DOCUMENT CHANGE REQUEST

DCR number 302	Changes required for: General	Originator: S JEFFERY
Date: 2006/11/14	Date sent: 2006/11/14	Organisation: ESA/ESTEC
Status: IMPLEMENTED

Title:	Transistors Low Power PNP, based on type 2N2905A		
Number:	5202/002	Issue:	1

ESCC Detail Specification No. 5202/002

1.6 PHYSICAL DIMENSIONS AND TERMINAL IDENTIFICATION

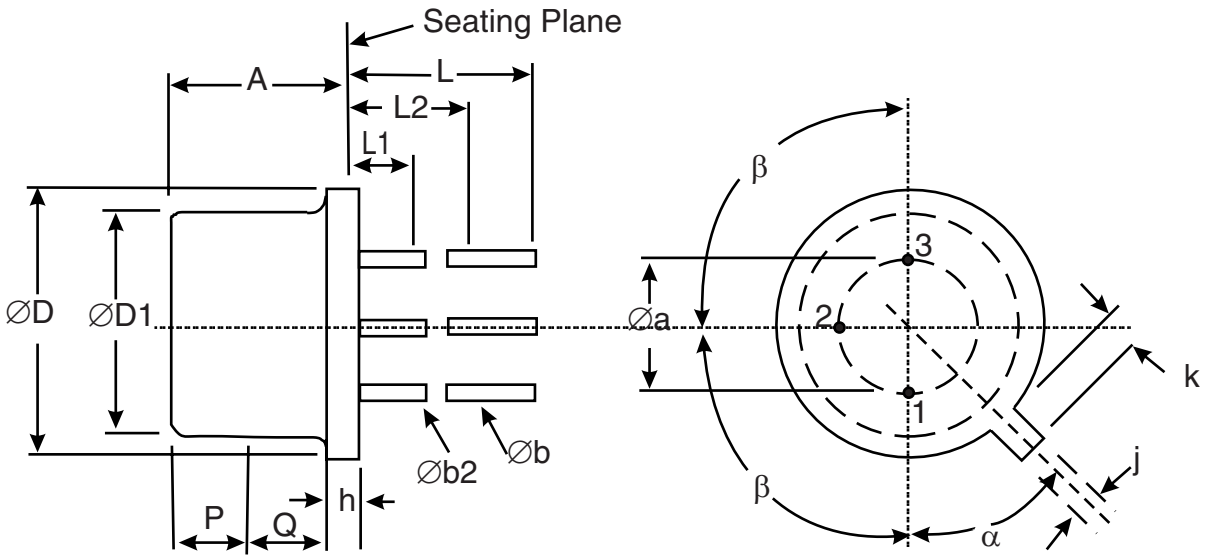
6. Para. 4.3.2 Weight Requirements moved to Component Type Variants table.
7. Figure 2 re-named â..Physical Dimensions and Terminal Identificationâ. and amended to reflect the TO-39 package currently supplied. Notes revised, including addition of a terminal identification note.

8. Para. 4.4.1 Case amended to fully define the TO-39 package.
9. Para. 4.4.2 Lead Material and Finish replaced by a reference to the Component Type Variants Para.

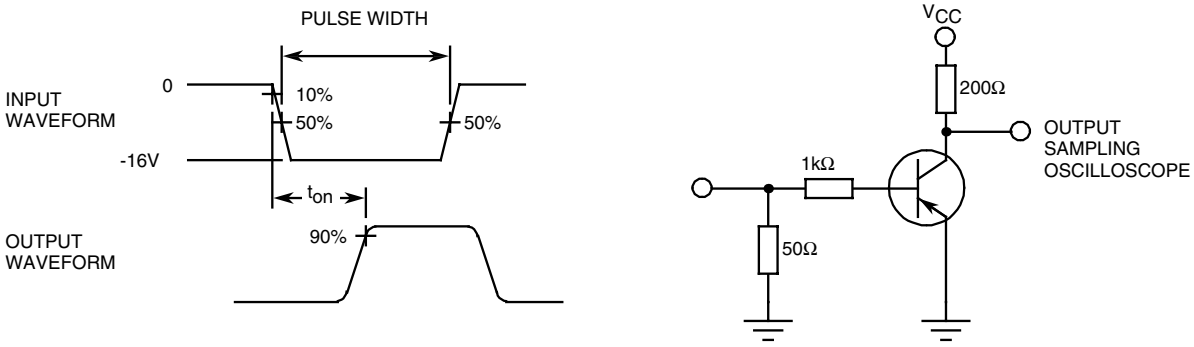
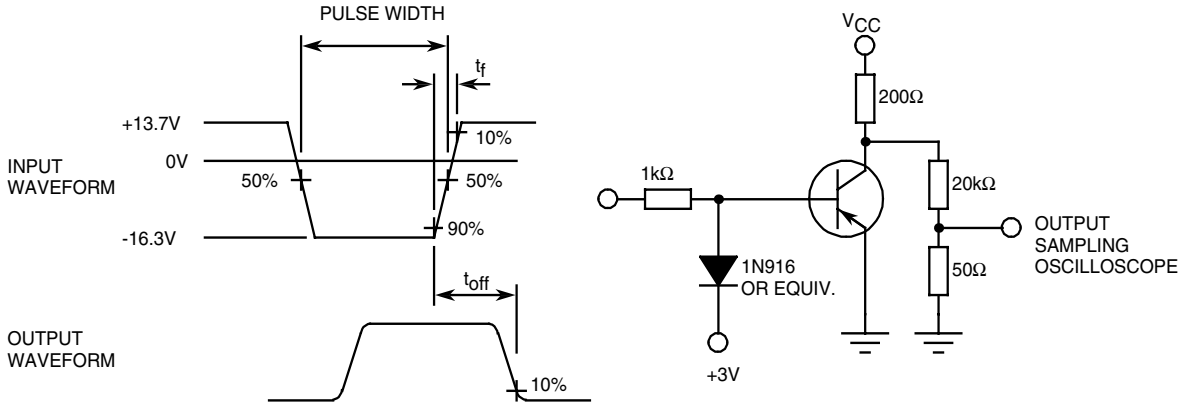
14. Table 2 and Figure 4: The Switching Times characteristics have been amended to reflect the new format.
15. Table 3 (High and Low Temperature Electrical Measurements): 100% inspection has been replaced by a sample of 5 components with 0 failures, or 100%, in line with the new Generic 5000 Issue 3.
